FINAL
MONITORING REPORT (MY2)

SLINGSHOT MITIGATION SITE
Rockingham County, North Carolina

Response to Monitoring Year 2 (2021) DMS Comments

Slingshot Mitigation Site
Cape Fear River Basin – CU# 03030002 – Rockingham County
DMS Project ID No. 100058
Contract # 7525

Slingshot Creek Stream Gauge Year 2 (2021 Data)

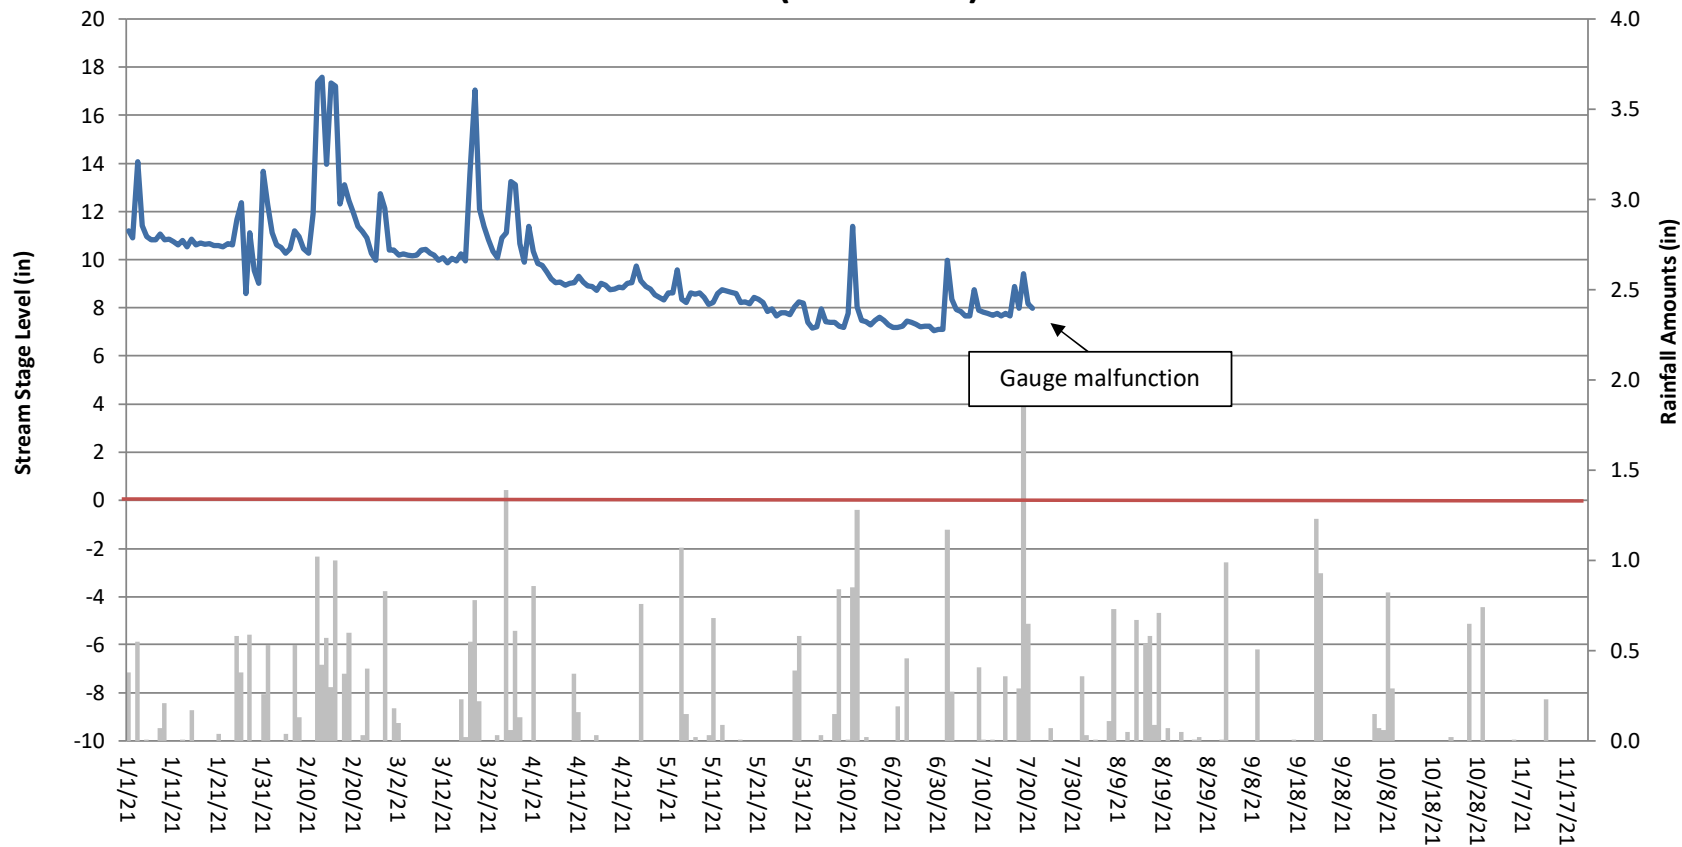
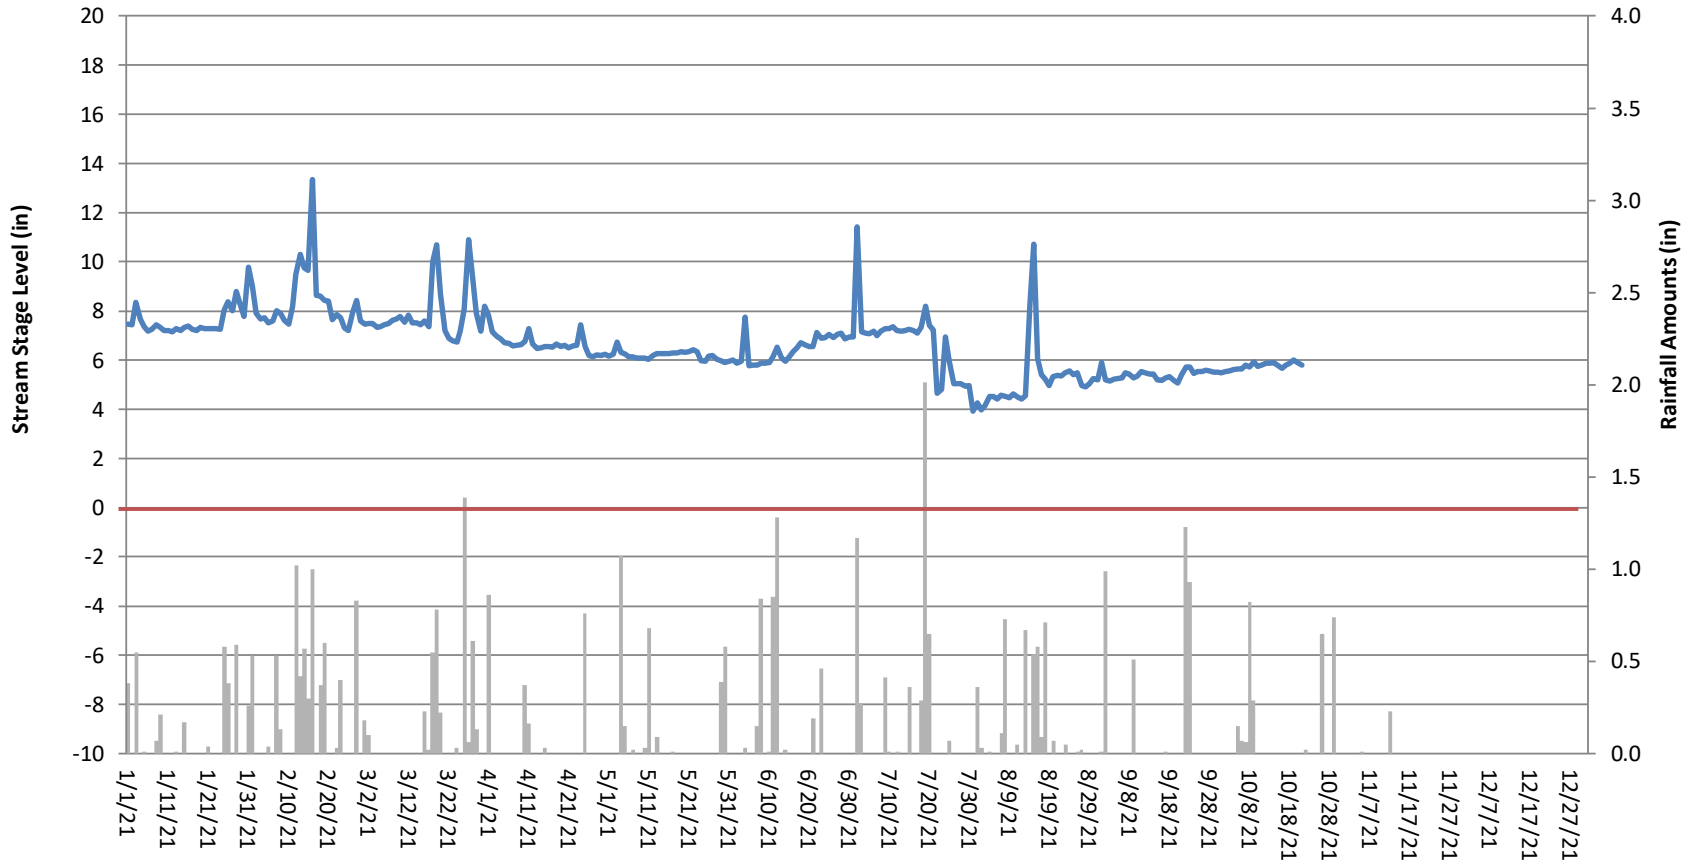
3. Please include the excel workbook used to create Tables 9 & 10.
[Response: This Excel file is included in the digital submittal.](#)
4. Please include the stream gauge figures in the report and send supporting soil temperature data with the resubmittal.
[Response: Stream gauge graphs are included in the final PDF, and soil temperature data is located in the master groundwater gauge workbook.](#)

Figure E1: Slingshot 30-70 Percentile Graph for Rainfall

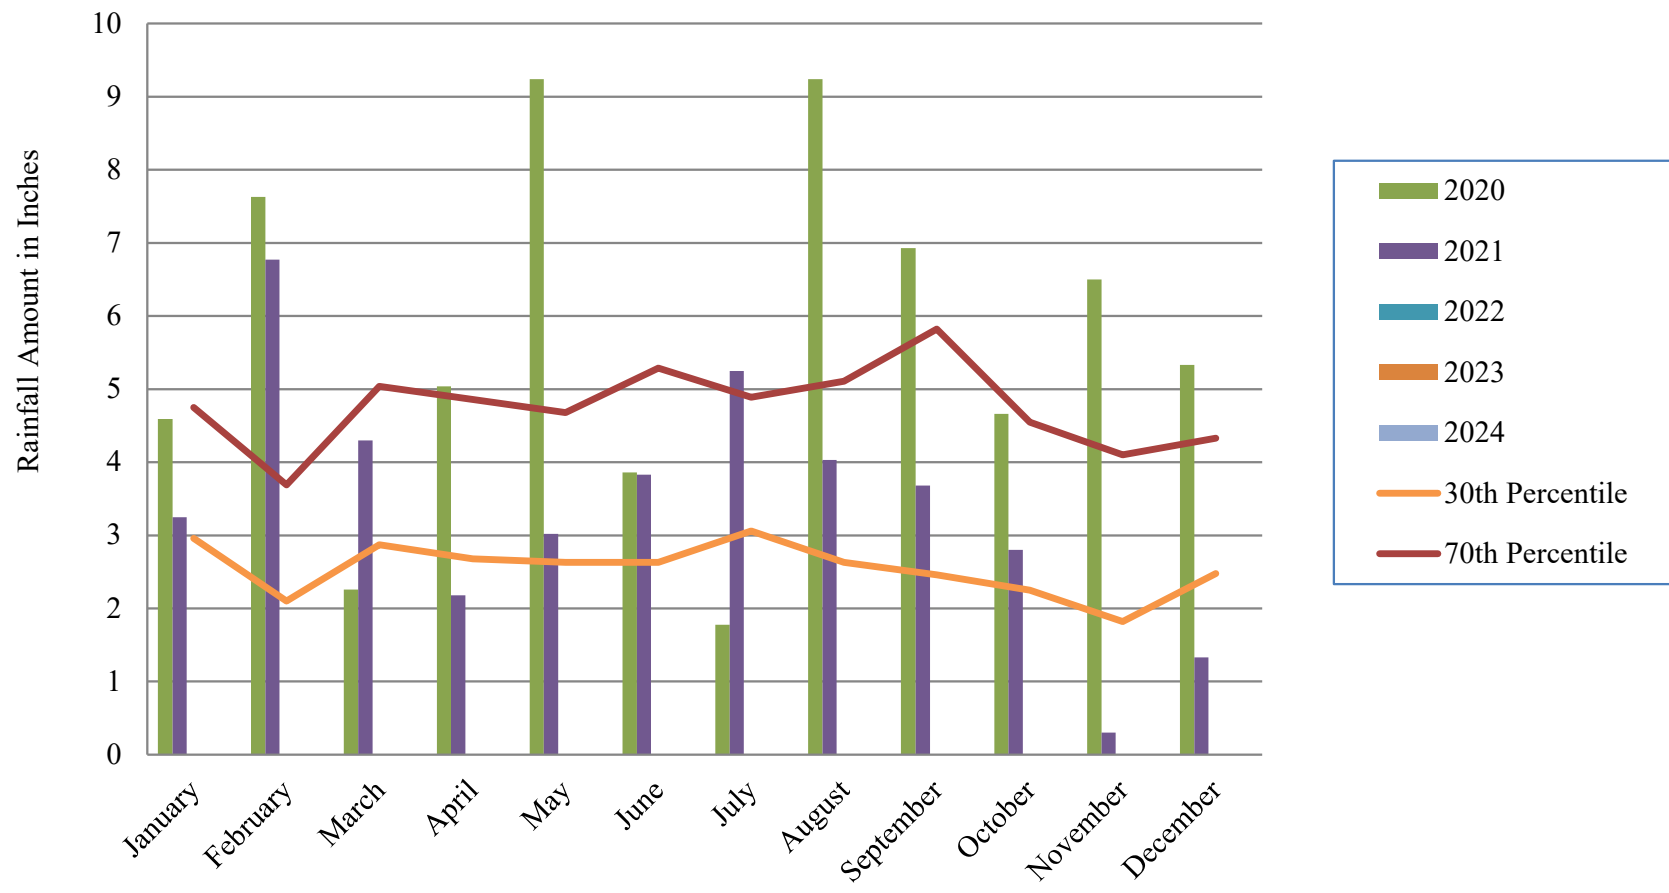
5. In Appendix E, please include a figure displaying the 30th and 70th percentile of monthly precipitation with the observed monthly precipitation, and submit the data used to create this figure.
[Response: This figure is included in Appendix E. The excel data used to create it is included in the digital submittal.](#)
